[Docket No. 96-SW-25-AD; Amendment 39-9779; AD 96-18-22]

Airworthiness Directives; Robinson Helicopter Company Model R44 Helicopters

ACTION: Final rule; request for comments.

96-18-22 ROBINSON HELICOPTER COMPANY: Amendment 39-9779. Docket No. 96-SW-25-AD.

FIGURE 1

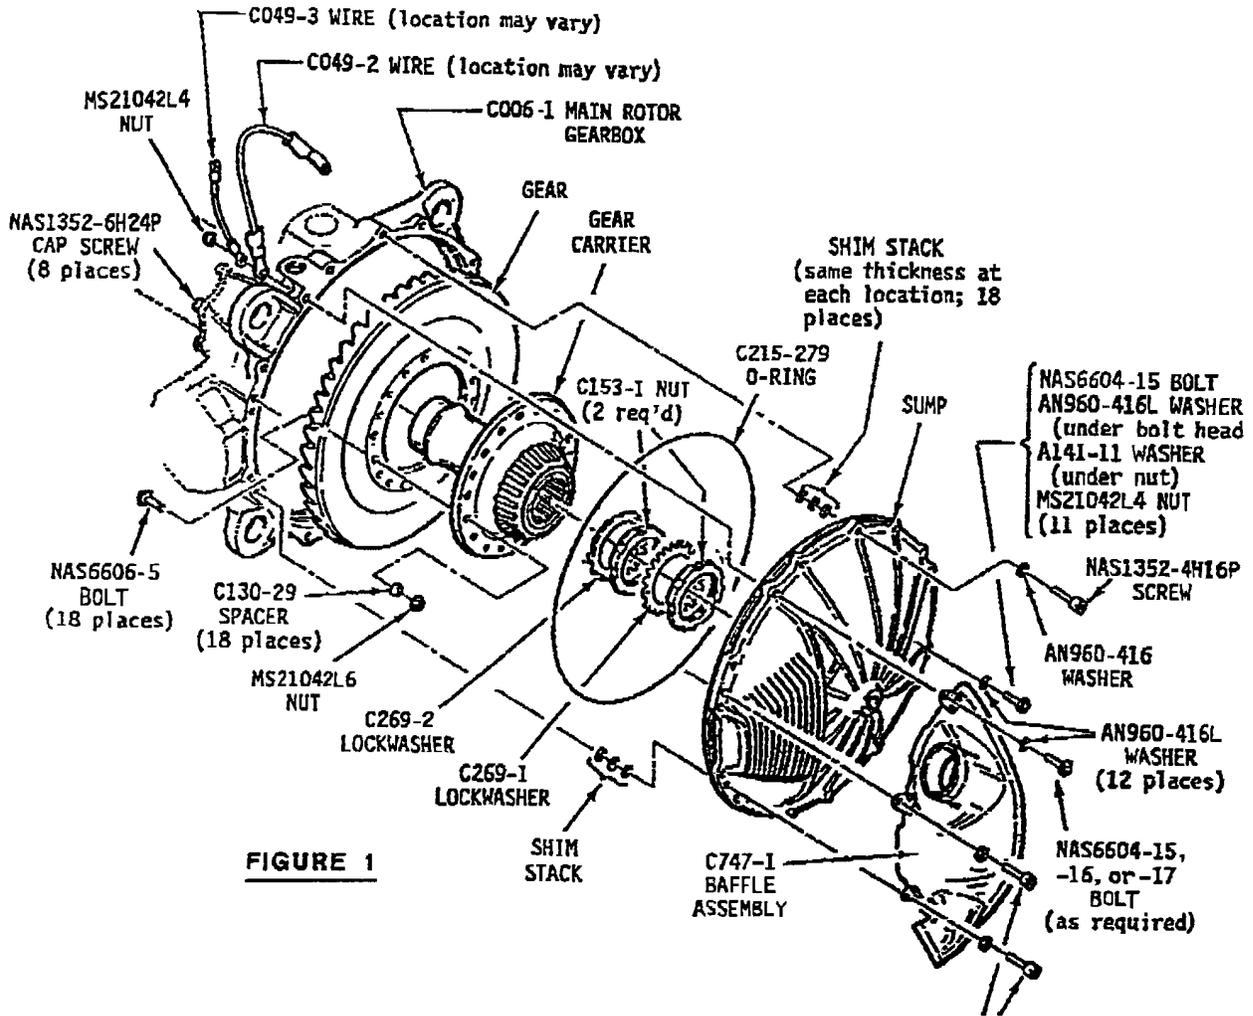
(b) Lay the gearbox on its side with input yoke up. Loosen the eight cap screws attaching the mast tube to the gearbox, but do not remove the screws. Remove the twelve bolts and six cap screws holding the sump and baffle in place (Figure 1). Note the location of ground wires.

FIGURE 2

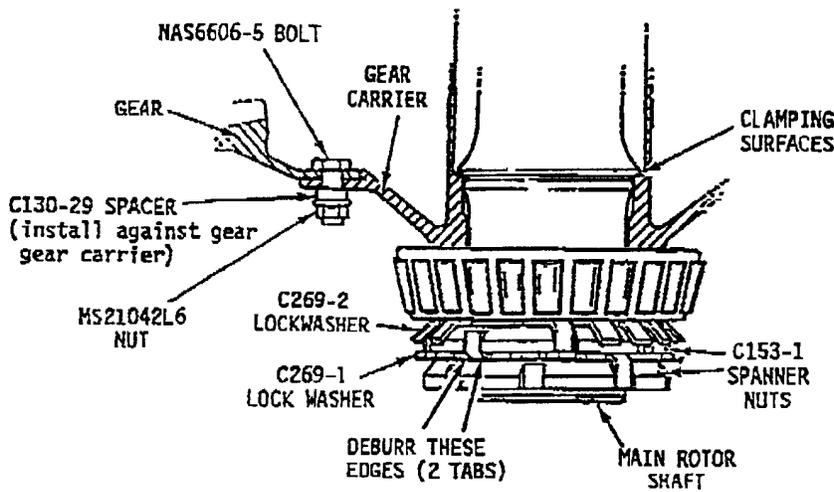
(h) Align the gear to the gear carrier and install NAS6606-5 bolts, spacers, P/N C130-29, and MS21042L6 nuts in 18 places (Figure 2). Keep the mating surfaces and hardware dry, clean, and free of oil. Torque the nuts to 40 ft.-lb. (includes self-locking torque) using the torquing sequence shown on Figure 3.

(l) Before installing the unused lockwasher, P/N C269-1, note that the edges are sharp on one side and rounded on the other. De-burr the sharp edges on two opposite tabs (Figure 2). This will reduce the chance of cracking when these tabs are bent. Install the lockwasher with the de-burred edges toward the first nut.
